Wayzata Planning Commission

Meeting Agenda

Date: September 16, 2016
To: Planning Commission
From: Jeff Thomson, Director of Planning and Building
Subject: Beacon Five

REPORT AND RECOMMENDATION OF APPROVAL OF PUD GENERAL PLAN OF DEVELOPMENT AND PROJECT DESIGN FOR A PUD DEVELOPMENT AT 529 INDIAN MOUND EAST

1 Site Plan

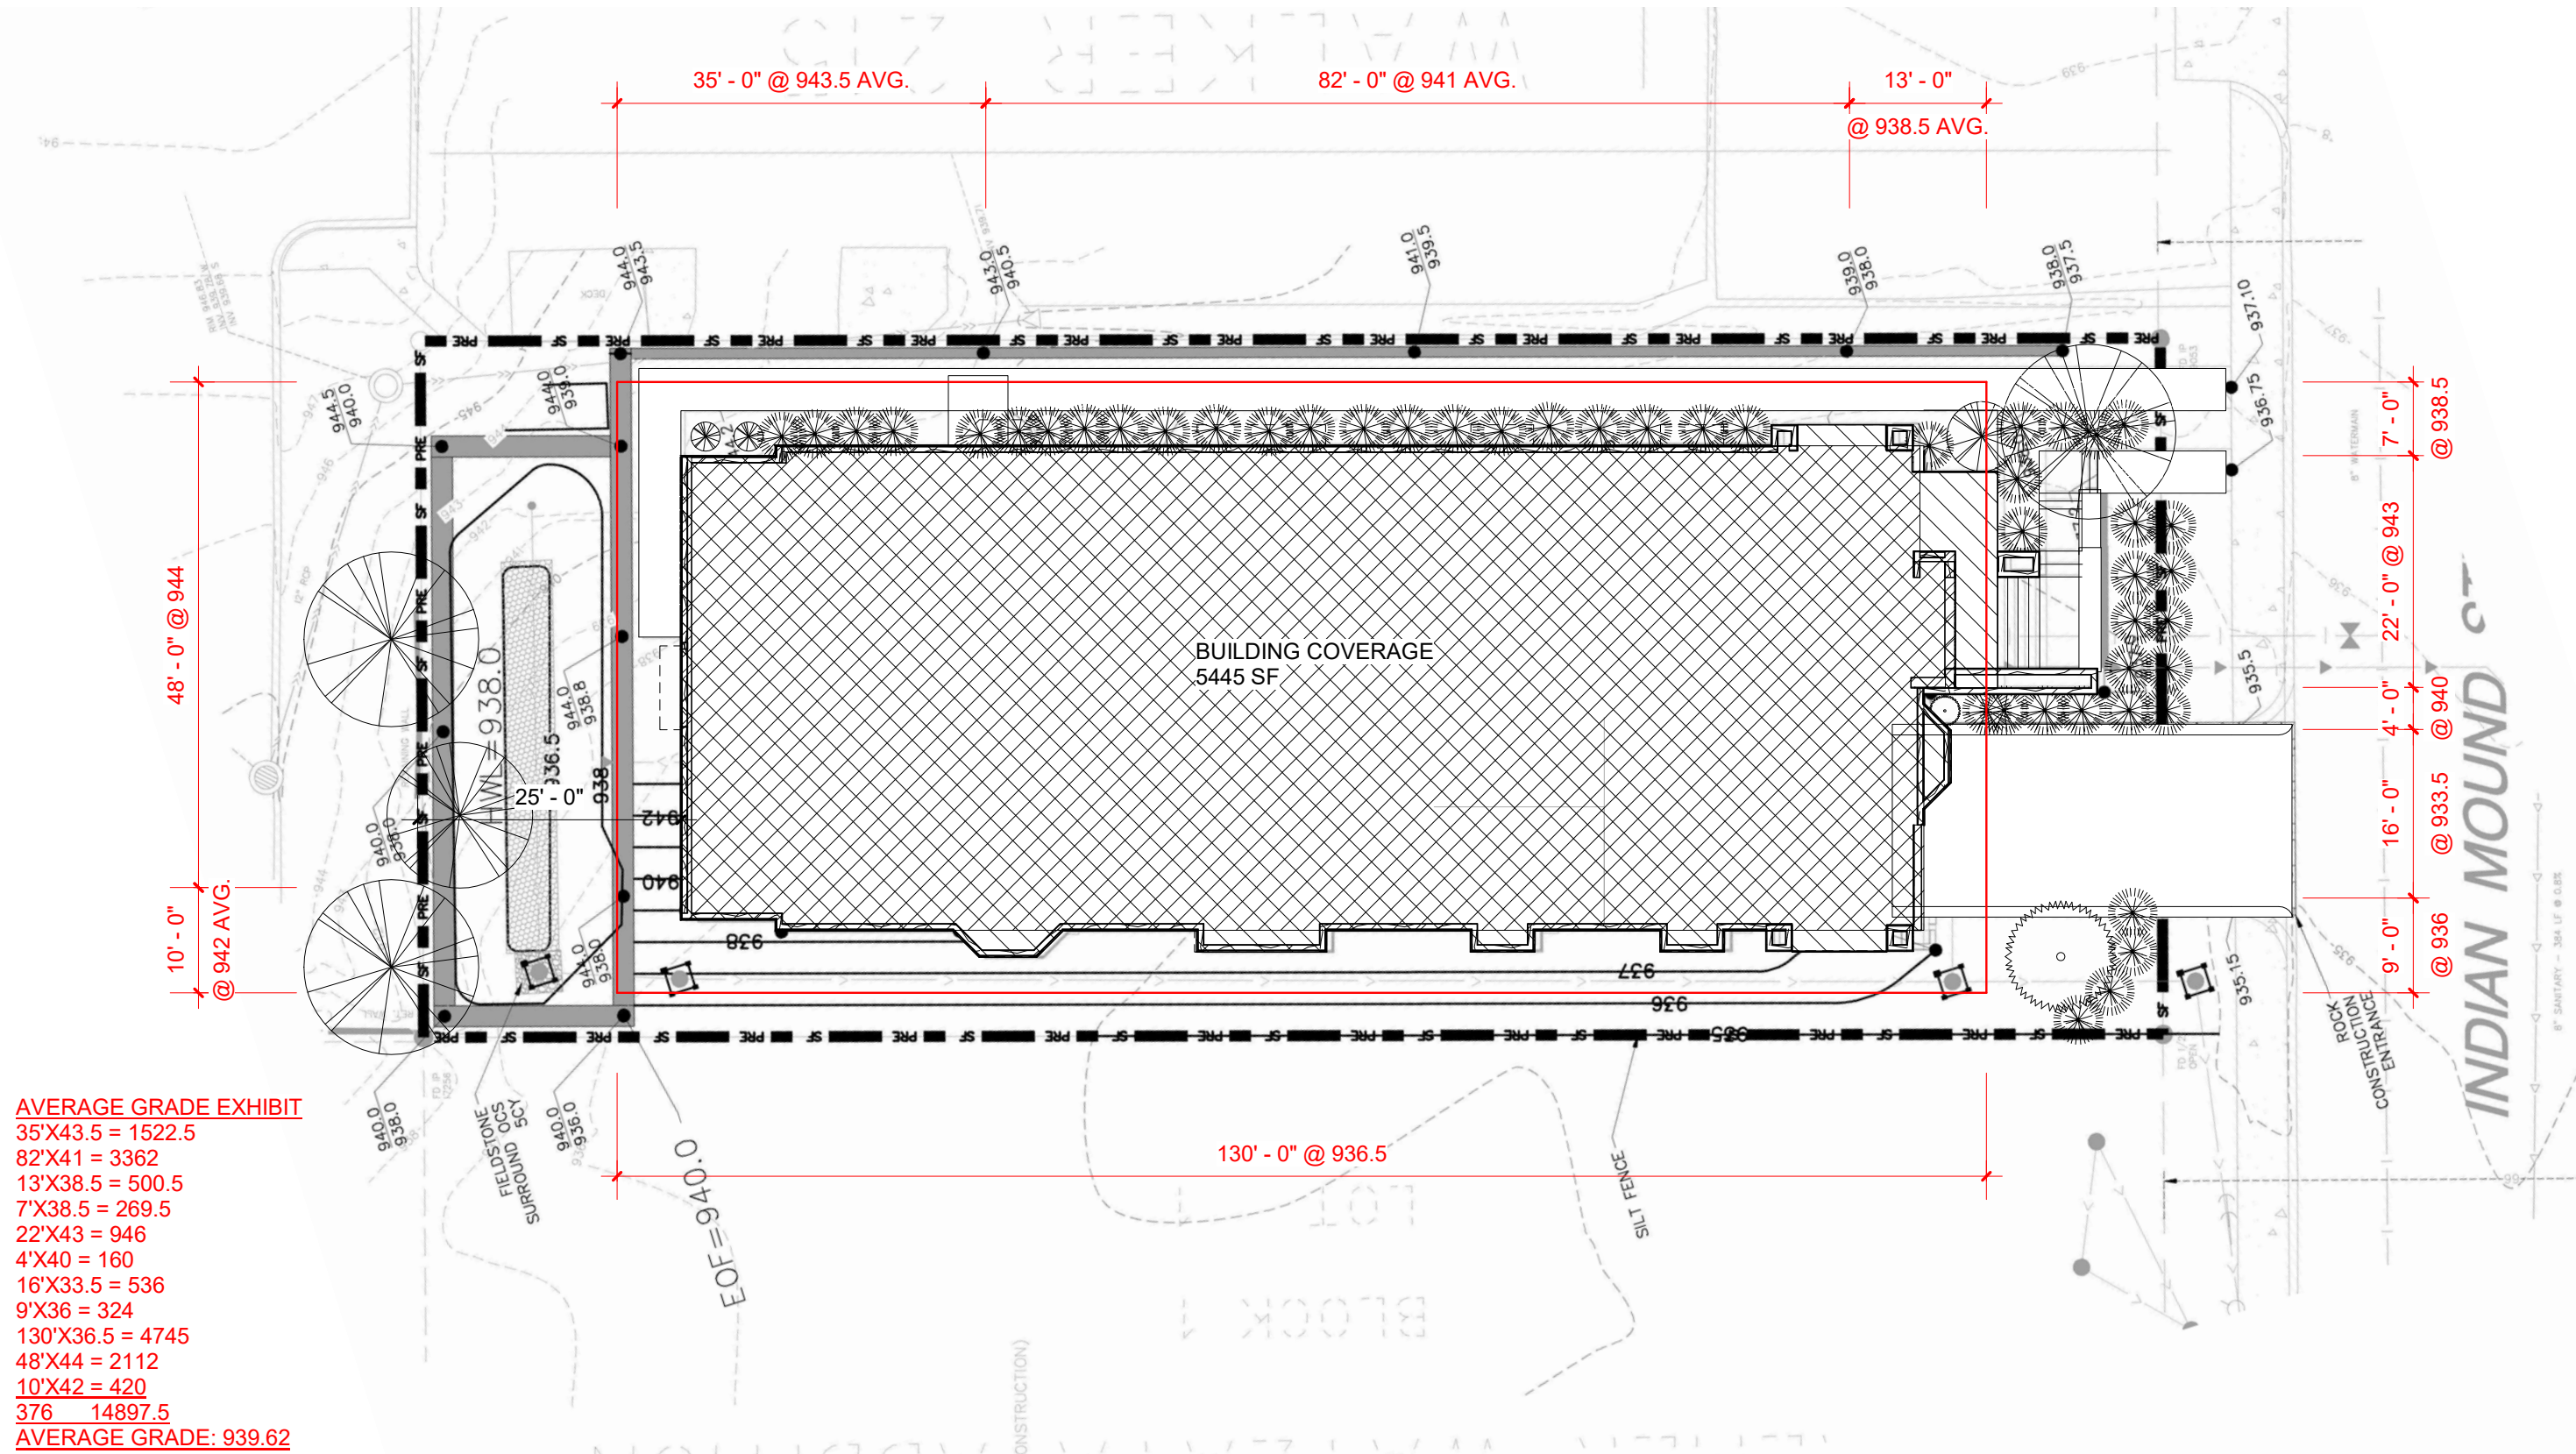
The Landscape Plan provided by the Applicant, 100 percent of the Significant and Heritage Trees on the site are proposed to be removed. The plans call for replacing 6 trees (18 caliper inches) on the site. Thus, there is a deficit of 164" replacement inches not provided in the landscape plan. The Applicant's proposed design **does not** comply with the Tree Preservation ordinance. Wayzata's Planning Commission should provide guidance on whether Landscape Plan revisions are required or whether the Applicants can provide a fee-in-lieu of tree replacement.
